## Evaluation of proposed move for Water Right No. 28234

Proposed: Move water right no. 28234 ID3 to the well authorized under 28234 ID2, 710 ft to the east. This change does not meet spacing requirements under GMD3 rules. A waiver of spacing rules will be required if the move is to be approved.

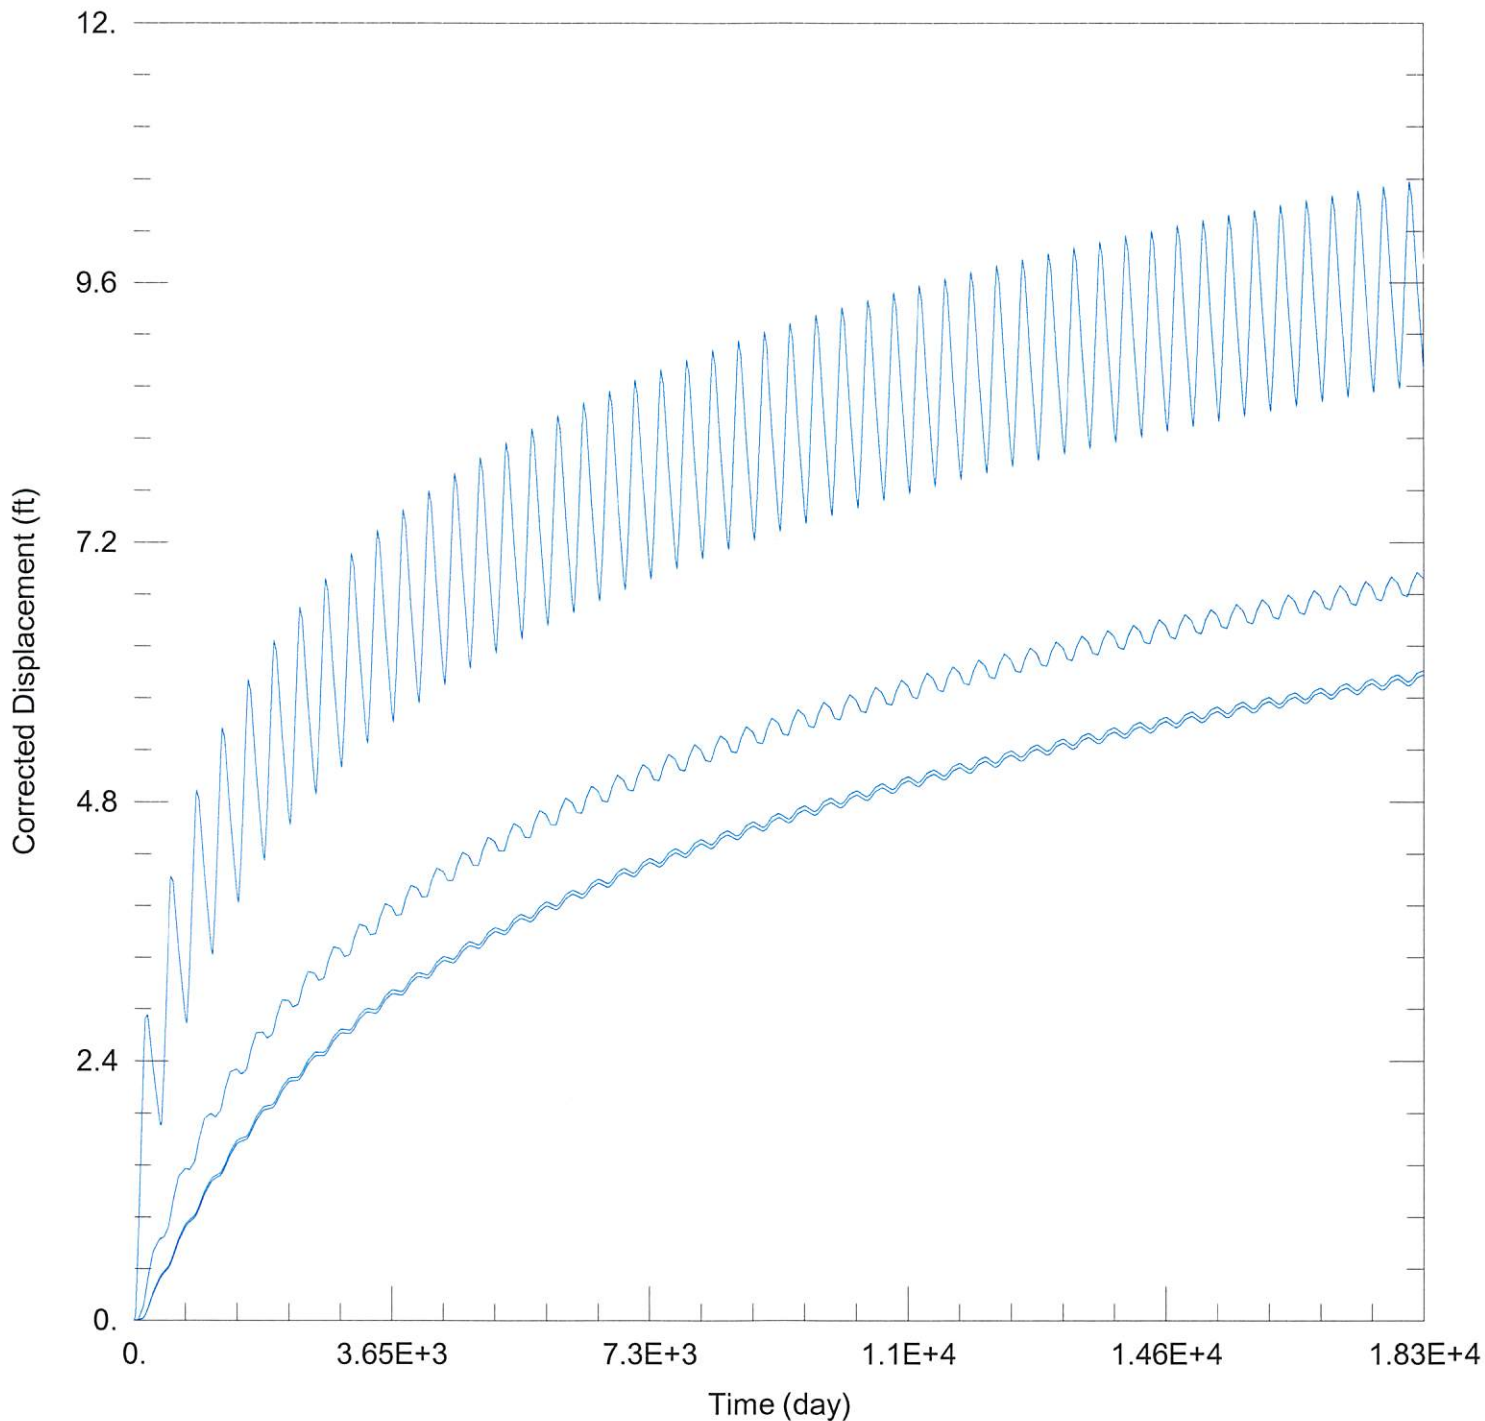
**50 year Theis Analysis:** The following values were used to run the analysis:

$S = 0.1931$ ,  $T = 2266.9 \text{ ft}^2/\text{day}$ ,  $tp_{\text{current}} = 137 \text{ days}$ ,  $Q_{\text{current}} = 790 \text{ gpm}$ ,  $tp_{\text{proposed}} = 233 \text{ days}$ ,  $Q_{\text{proposed}} = 1050 \text{ gpm}$

28128:	Drawdown from current location = 5.97 ft
	Drawdown from proposed location = 13.45 ft
	<b>Net drawdown = 7.5 ft</b>
18158:	Drawdown from current location = 6.01 ft
	Drawdown from proposed location = 13.54 ft
	<b>Net drawdown = 7.5 ft</b>

1364: Drawdown from current location = 6.92 ft  
Drawdown from proposed location = 15.56 ft  
Net drawdown = **8.6 ft**

21634: Drawdown from current location = 10.54 ft  
Drawdown from proposed location = 22.89 ft  
Net drawdown = **12.4 ft**

Net drawdown exceeds the drawdown allowance of 1.5 ft for all wells within 1 mile of the proposed location. Critical well analysis is necessary on those wells.
